TECHNICAL BULLETIN TECH-01-2020 REV.A

# VW 2.0L - 830323-5006S TURBOCHARGER REPLACEMENT

11<sup>TH</sup> SEPTEMBER 2020

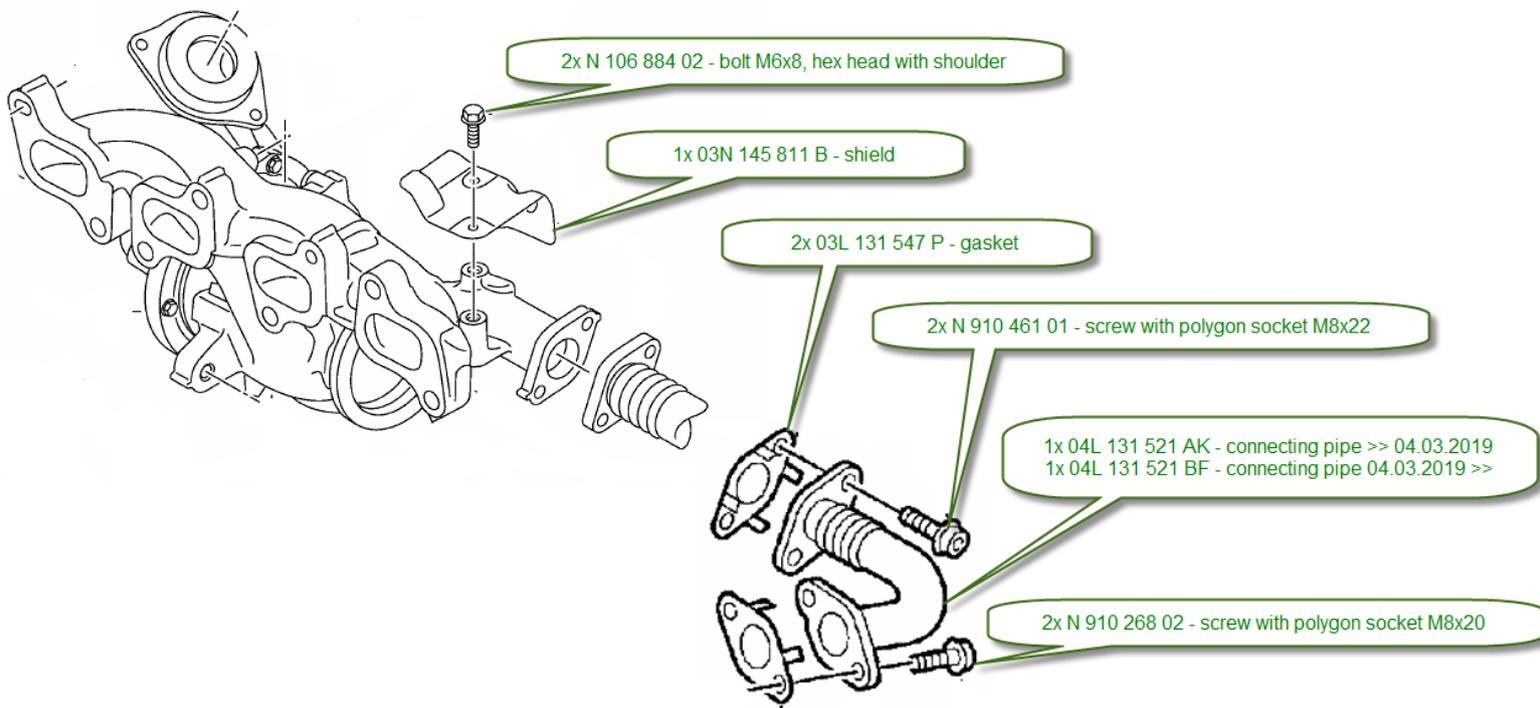
As a replacement is available turbocharger 04L 253 014 M / 873767-5001S, which is not a direct service replacement for 830323-5006S.

- There is a different position of the flange for EGR pipe on turbine housing – see below

- From Garrett - Turbocharger 873767-5001S
- From franchised VW dealer
  - EGR pipe
  - Gaskets
  - Heatshield
  - Necessary fasteners
